<b>Delegated Report</b>		<b>Analysis sheet</b>		<b>Expiry Date:</b>		<b>23/01/2023</b>	
		n/a		<b>Consultation Expiry Date:</b>		<b>22/01/2023</b>	
<b>Officer</b>				<b>Application Number:</b>			
Tony Young				2022/5225/P			
<b>Application Address</b>				<b>Drawing Numbers</b>			
25 Marquis Road London NW1 9UD				Refer to draft decision notice			
<b>PO 3/4</b>	<b>Area Team Signature</b>	<b>C&amp;UD</b>	<b>Authorised Officer Signature</b>				
<b>Proposal:</b>							
Repositioning of single-glazed timber frame sash window at 2nd floor level on rear elevation (200mm higher).							
<b>Recommendation:</b>		<b>Refuse Planning Permission</b>					
<b>Application Type:</b>		<b>Householder</b>					
<b>Conditions or Reasons for Refusal:</b>		<b>Refer to Draft Decision Notice</b>					
<b>Informatives:</b>							
<b>Consultations</b>							
<b>Adjoining occupiers and local groups:</b>		No. notified	<b>0</b>	No. of responses	<b>00</b>	No. of objections	<b>00</b>

1.1 Planning permission is sought to reposition an existing single-glazed timber framed sash window located at 2nd floor level on the rear elevation. The replacement window would be positioned 200mm higher up on the rear elevation (see

Image 1 – showing existing and proposed rear elevation of host property

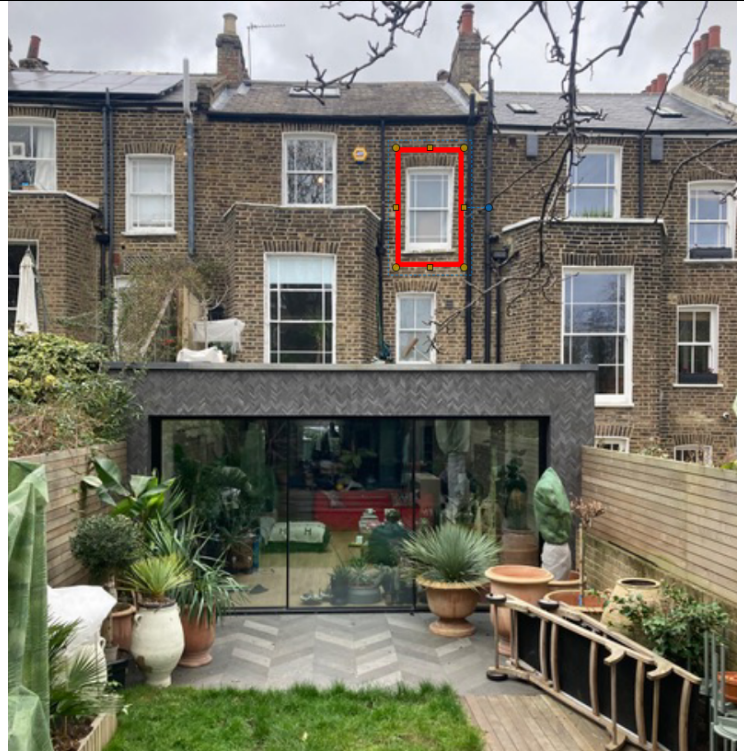
- 3.5 It should firstly be noted that the Council raises no objection to the proposed window in terms of its design, size or materials as it would closely match a similar single-glazed window which it would replace (as shown in Image 3 above). The principal concern with the current proposal is by virtue of its proposed siting and location given its particular site context and this report sets out the reasons for this below.
- 3.6 While it is recognised that the rear elevations of some of the properties along the terrace in which the host property is situated have been altered to some degree in the past at ground floor level, the upper floors appear mainly unaltered and well maintained (see Image 4 below).

- 3.11 In this context, the proposed repositioning of an existing timber framed sash window higher up on the rear elevation would adversely alter the existing integrity in character and appearance of the terrace of properties when viewed together, by introducing an incongruous addition which would disrupt and imbalance the architectural symmetry and composition of the rear elevations of these buildings when read as a group (nos. 23 to 35 Marquis Road in particular). As such, the proposal would not respect the prevailing historic pattern, rhythm and symmetry of the buildings at the rear, and as a consequence, fails to preserve the existing character and appearance of the host building and terrace as a whole, as well as, the wider conservation area.
